**FINAL ENVIRONMENTAL IMPACT REPORT**  
City of Pasadena  
Planning & Community Development Department

**Hill and Colorado  
Project**

August 2016

Figure 3.7-6  
Existing Zoning Designations  
Hill and Colorado Project

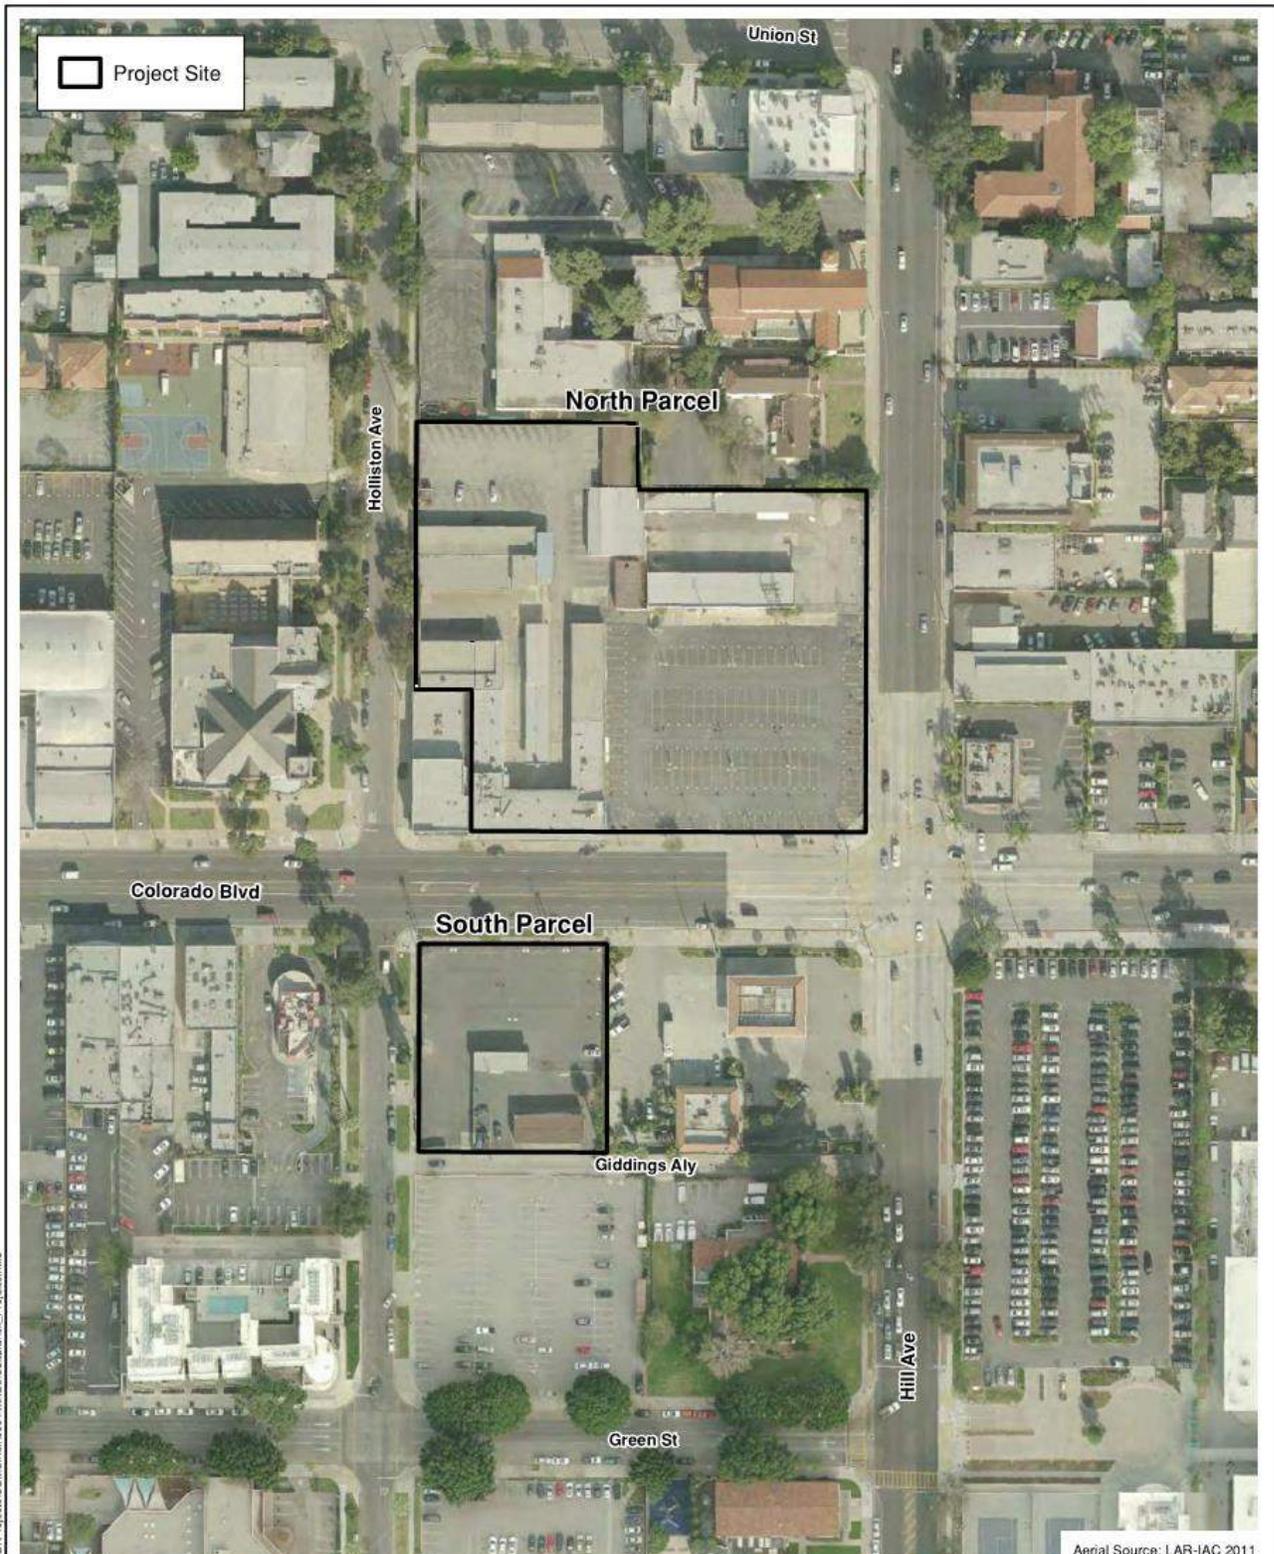
Draft EIR-Page 3.7-18, Figure 3.7-6, Existing Zoning Designations:

The subject figure has been revised to correct the boundary of the North Parcel. The revised figure is presented herein on the next page.
